Service Bulletin

SUBJECT: Engine Oil-Fill Procedure

0606-T3

1

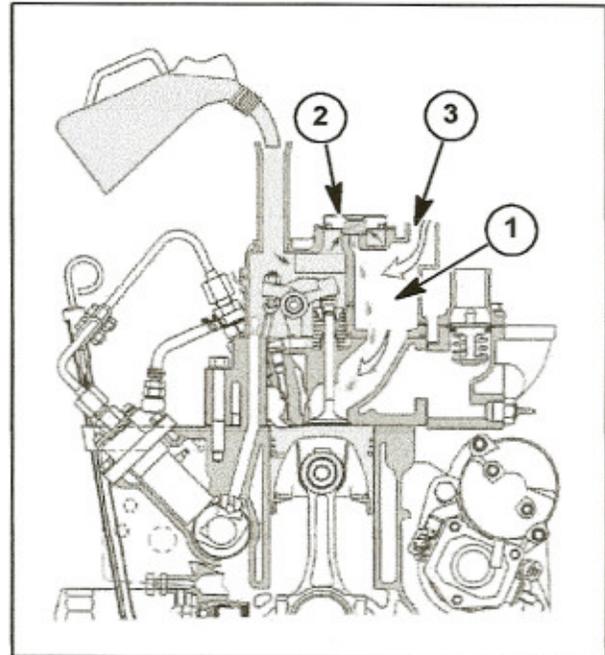
With the introduction of an engine breather valve, hydraulic engine lock can occur if the oil-fill procedure described in this bulletin is not followed. Hydraulic engine lock can lead to catastrophic piston and connecting-rod damage.

The engine breather valve was introduced to address the environmental concern of blow-by gasses that vent into the atmosphere. Blow-by gasses now circulate into the intake manifold, 1, from the engine crankcase through the engine breather valve, 2, and mix with air in the intake air manifold, 3, to be burnt in the combustion process, rather than simply vent to the atmosphere. If the oil-fill procedure described in this bulletin is not followed, oil can flow to the intake manifold through the engine breather valve.

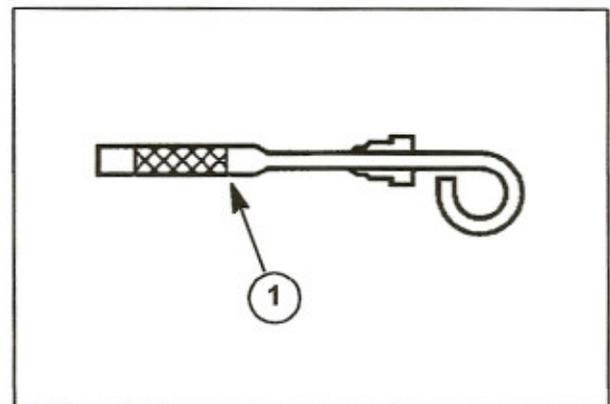
Do not overfill the engine oil above the maximum level mark on the dipstick, 1.

Follow these steps to change or top up the oil in one of these engines:

1. Place the unit on a level surface, and remove the engine oil filler cap and **the dipstick**.
2. Clean the dipstick, but do not replace it yet. **The empty dipstick tube provides necessary crankcase ventilation.**

3. If **changing** the oil, drain the oil and change the filter as outlined in the Owner's Manual. If **topping up** the oil, check the level on the dipstick.

4. Whenever it is necessary to add oil, refer to the Owner's Manual for the correct oil specification and quantity.
5. Fill the engine **slowly** with the recommended type and quantity of oil, as follows:

- Always add oil with the dipstick removed from its tube to provide ventilation.
 - **Do not allow the rate to exceed two liters (2.11 quarts) per minute.**

- Ensure that time is allowed for the oil to drain from the valve cover into the engine oil pan.
 - Extra caution is required when engine oil is added with larger containers or automatic supply dispensers.

6. Replace the dipstick.
7. Remove the dipstick and visually inspect it for correct oil level. Add more oil if necessary, with the dipstick removed.
8. Install the filler cap. If **topping up**, you are finished.

9. Operate the engine until it reaches the correct operating temperature. This ensures that the oil filter is filled.
10. Stop the engine.
11. Allow the engine to cool for 15 minutes.

12. Re-check the oil level on the dipstick. Add oil if necessary, with the dipstick removed.
